To
Subject WB/A-OU Proposed Plan Comments

Re: Comments on Willow Boulevard/A-Site Operable Unit Proposed Plan
Kalamazoo River Superfund Site
Kalamazoo, Michigan
BBL Project #: 645.81/82.690 #2

KALAMAZOO RIVER STUDY GROUP PORTAGE CREEK
KALAMAZOO RIVER SUPERFUND SITE
WILLOW BOULEVARD/A-SITE

FIGURE
1

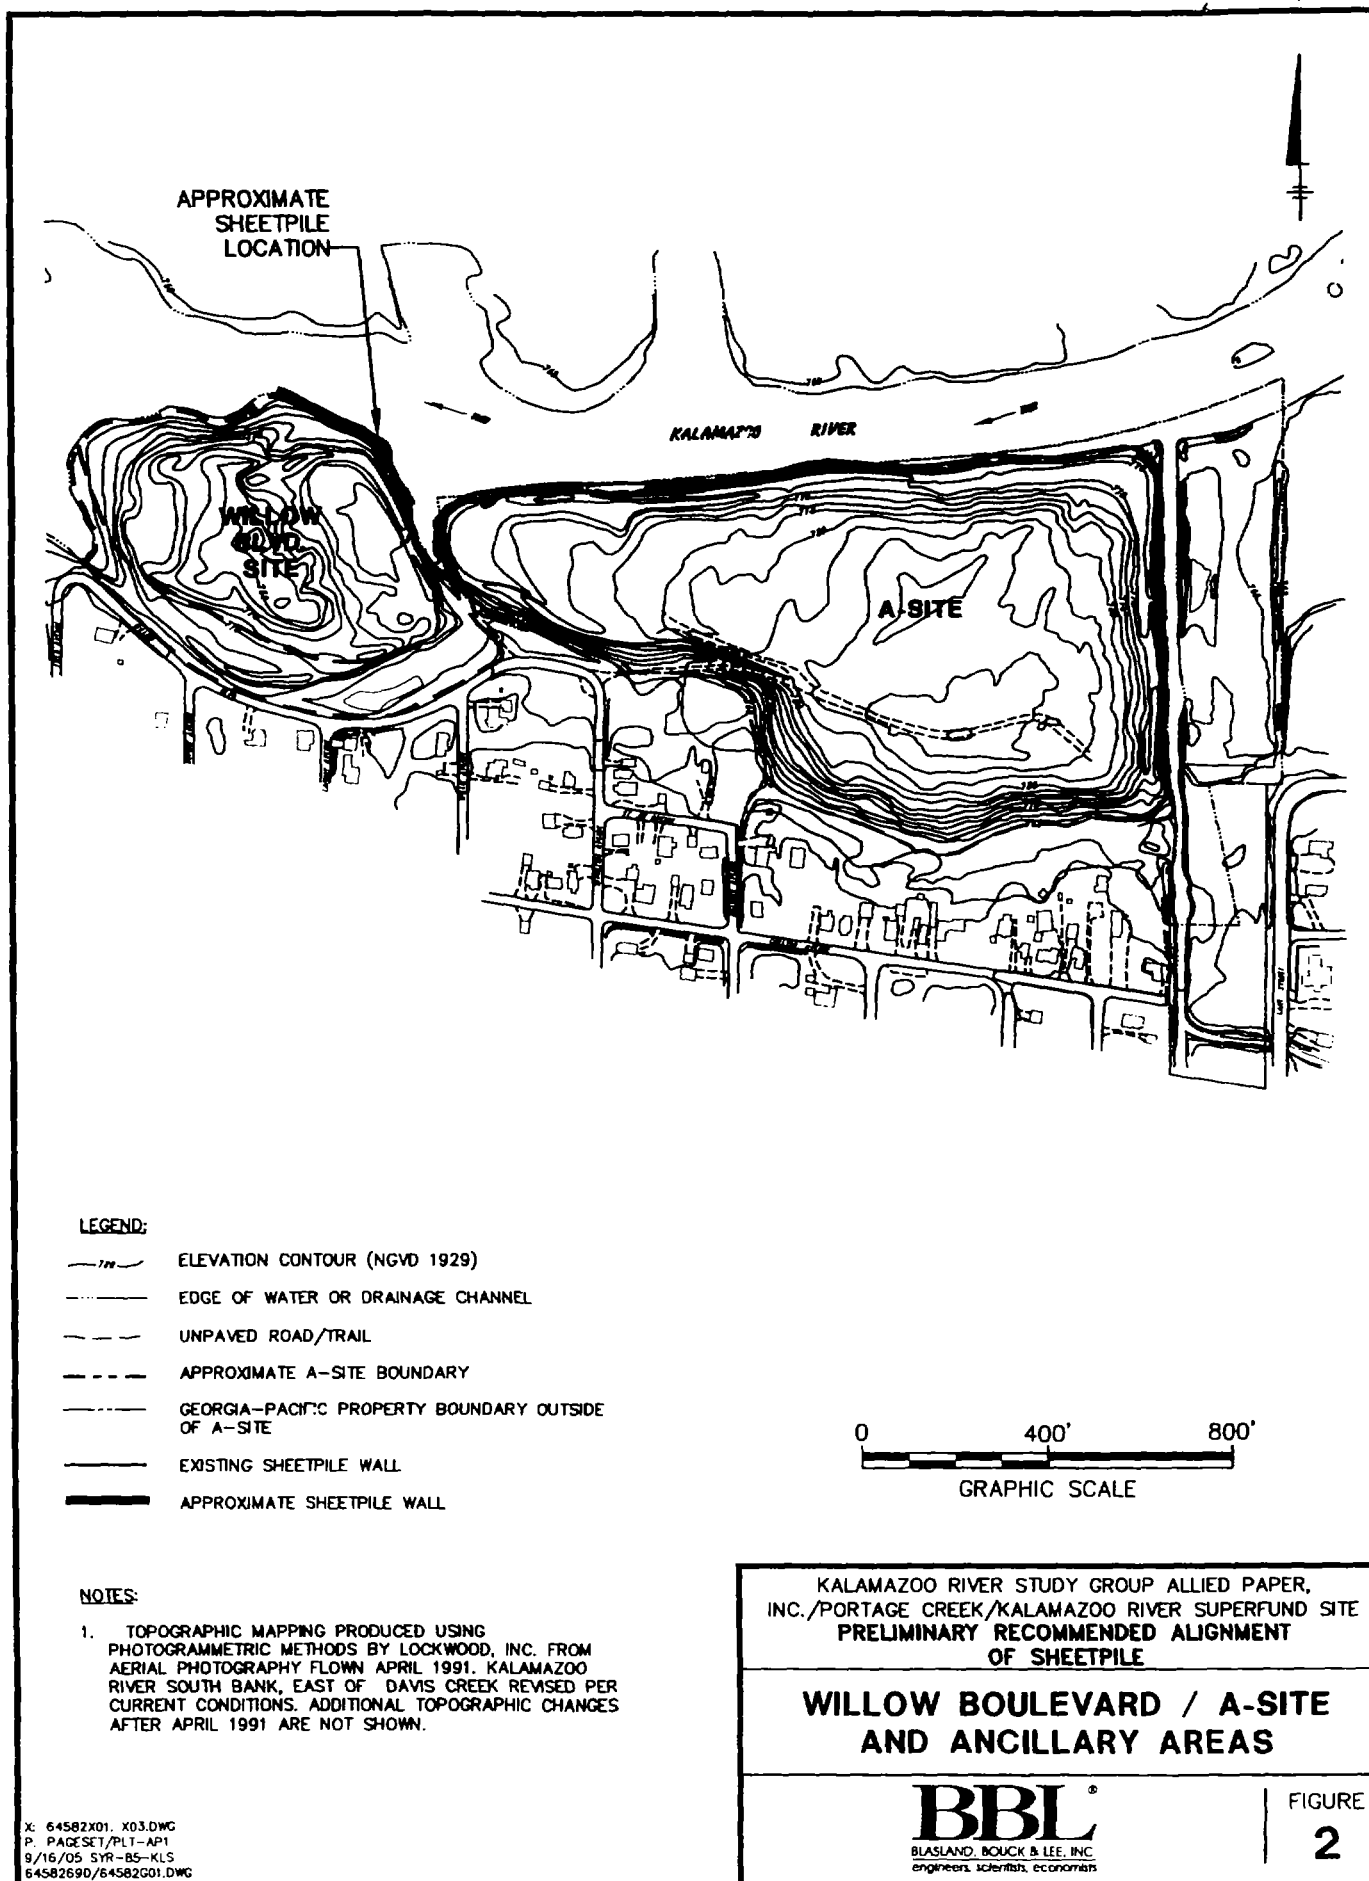
We recommend that EPA consider rewording the description of historical disposal at the Willow Boulevard site. Page 3 of the Proposed Plan indicates that paper residuals disposed at the Willow Boulevard site were placed directly into the river. This is not accurate. As seen on the attached 1950 aerial photograph (Figure 1), channel islands were well-established in this area of the river long before the disposal of residuals. A substantial portion of the residuals were placed over the islands themselves, not into water as implied in the Proposed Plan.
